Access Compliance Report

Public Rights-of-Way

Intersection ID: 3513	Main Street: TAVERNAY_PY	Cross Street: THOMASHIRE_CT	Location:	E
ADA ID: D30FB6AB2106	Ramp Type: Perp	Initial Pass/Fail: Fail	Overall Compliance: No	Severity Score: 13.75
Codes/Mitigation Info/Possible Solution		Field Measurements/Component Compliance

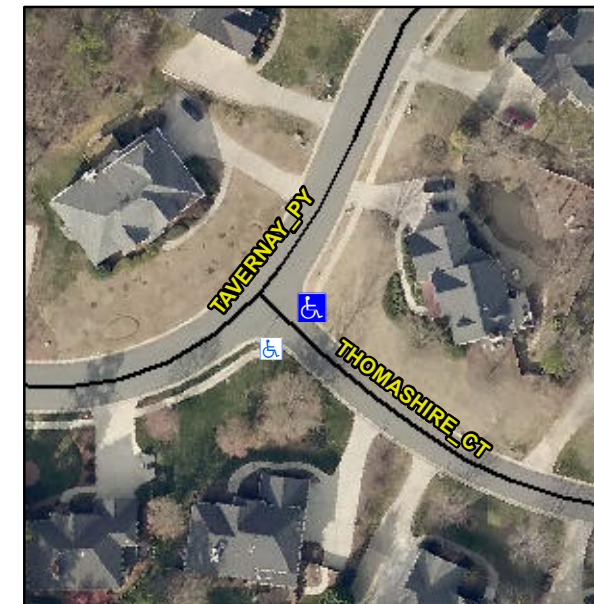
Not Found, R304.2.2, R304.5.3

Compliance	Description	Data	Compliance	Description	Data
N/A	Ramp Length (in)	41.0	No	Ramp Slope (%)	10.2
Yes	Ramp Width (in)	68.0	No	Ramp XSlope (%)	4.3
N/A	Flare Type LT	N/A	N/A	Flare Type RT	N/A
N/A	Flare Slope LT (%)	N/A	N/A	Flare Slope RT (%)	N/A
N/A	Flare Traversable LT?	N/A	N/A	Flare Traversable RT?	N/A
N/A	Landing Length (in)	N/A	N/A	DWS Provided?	N/A
N/A	Landing Width (in)	N/A	N/A	DWS Contrast?	N/A
N/A	Landing Slope (%)	N/A	N/A	DWS Length (in)	N/A
N/A	Landing X Slope (%)	N/A	N/A	DWS Full Width?	N/A
N/A	Landing Curb? (Y/N)	N/A	N/A	DWS Offset (in)	N/A
N/A	Shared Landing?	N/A			
N/A	Gutter Ponding?	N/A	N/A	Gutter Slope (%)	N/A
N/A	Gutter Lip Ht (in)	N/A	N/A	Gutter X Slope (%)	N/A
N/A	Painted X Walk1?	No	N/A	Painted X Walk2?	N/A
	X Walk 1 Direction	To SW		X Walk 2 Direction	N/A
N/A	X Walk 1 Width (in)	N/A	N/A	X Walk 2 Width (in)	N/A
	X Walk 1 Slope (%)	5.7		X Walk 2 Slope (%)	N/A
	X Walk 1 X Slope (%)	0.7		X Walk 2 X Slope (%)	N/A

Remove & Replace Entire Ramp.
